Ref. 1917 / INV / 443 /5 / 05

SAFETY RECOMMENDATION

Subject: ATR-72, registration marks TS-LBB. Accident occurred on 6 August 2005 offshore Palermo airport (Sicily - Italy).

Refuelling tests aircraft ATR-72

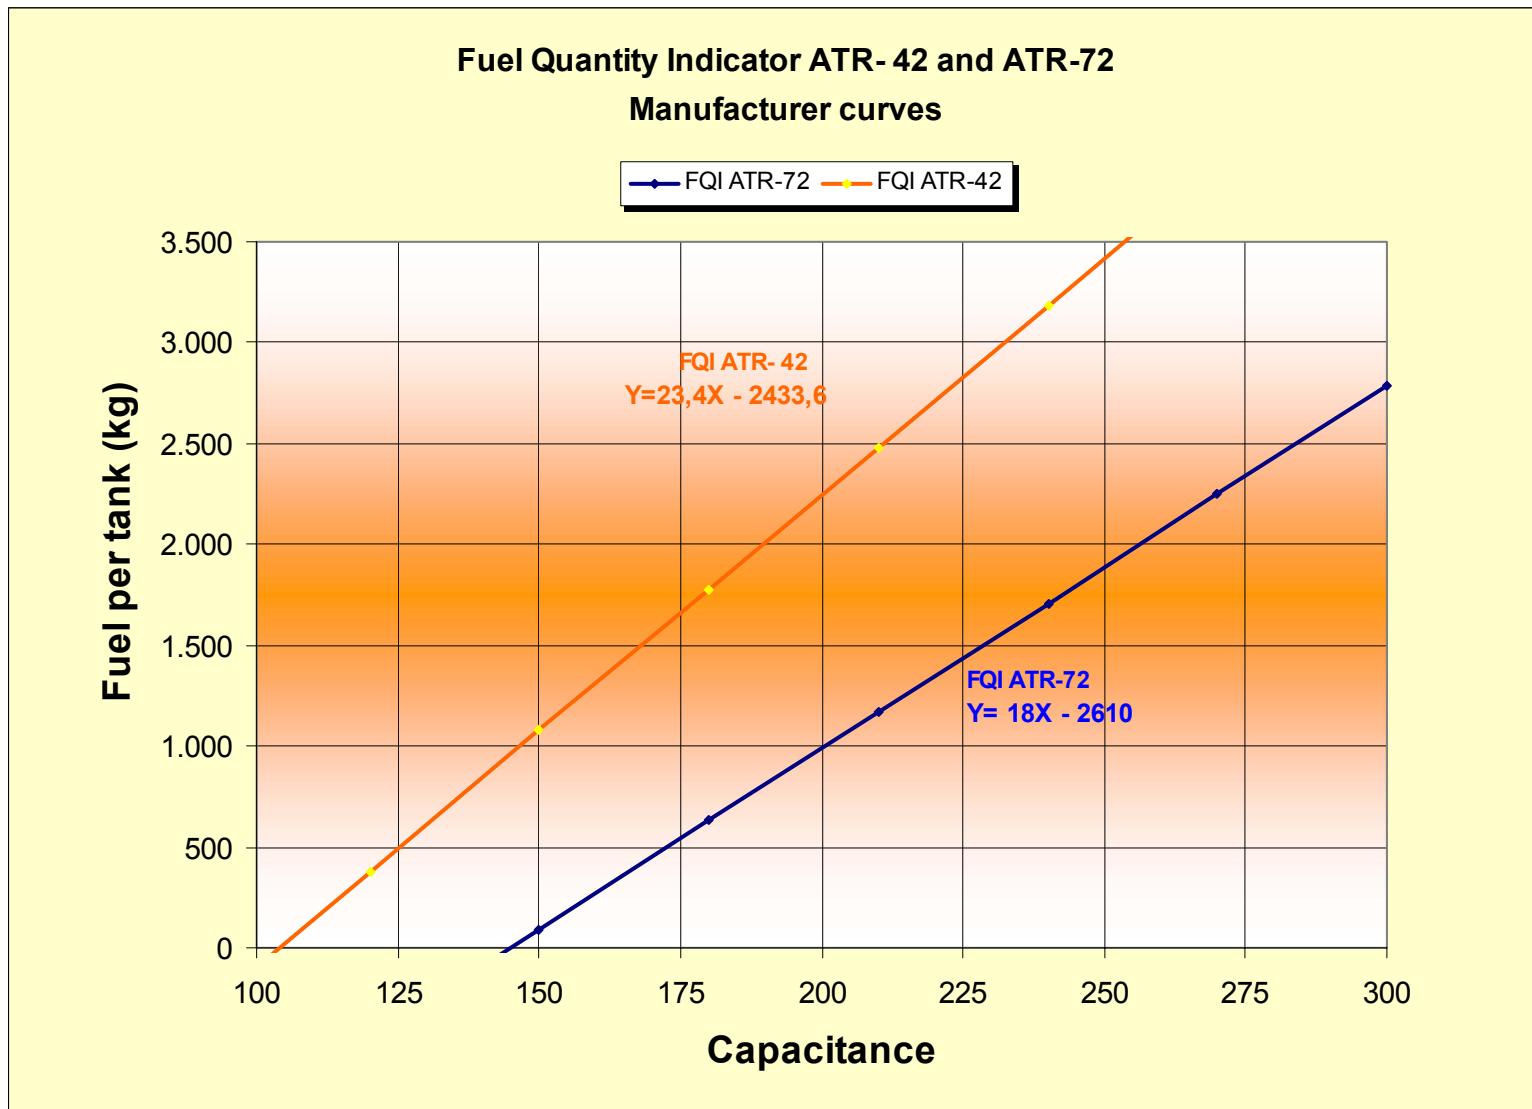
Test results showed that a FQI for the ATR-42 installed on a ATR-72 introduces a non conservative error (i.e. the indicated values of the fuel quantity is greater than the fuel actually present on board),

which is linearly increasing with the fuel quantity and not less than 900 kg per tank; this means that with zero fuel on board the FQI ATR-42 readings for each tank is 900 kg (e.g. total fuel on board indicated by the FQI is not less than 1800 kg, see figure in Annex).

- should require an ATR-72 and ATR-42 fleet inspection in order to verify the installation of the applicable Fuel Quantity Indicator.

- should consider the possibility to mandate a modification of the Fuel Quantity Indicator installation in order to prevent any incorrect fitting.
